Product / Process Change Notification

N° 2020-099-A

Introduction of new lead frame and lead finish material for dedicated products in TO247 package

Lead finish material

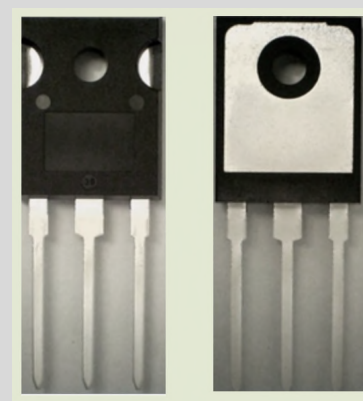
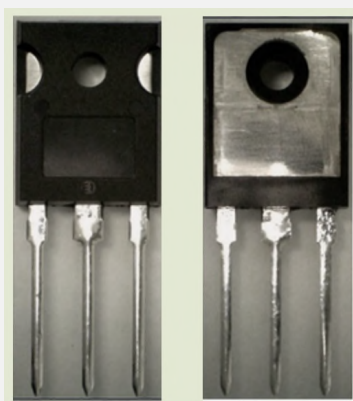
Lead finishing process

99.3% Sn / 0.7% Cu

100% Sn

Tin Dip

Electro-plated

Lead frame design

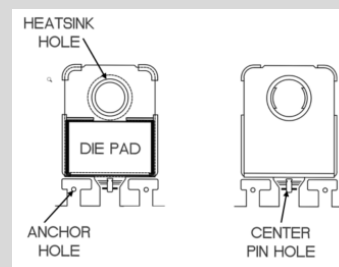
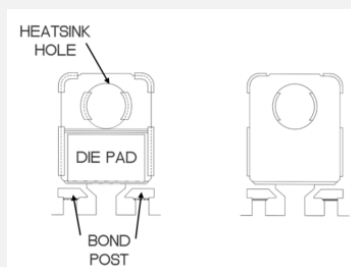
Subject: Change of lead frame and lead finish material

Reason: Standardization of assembly and lead finishing process
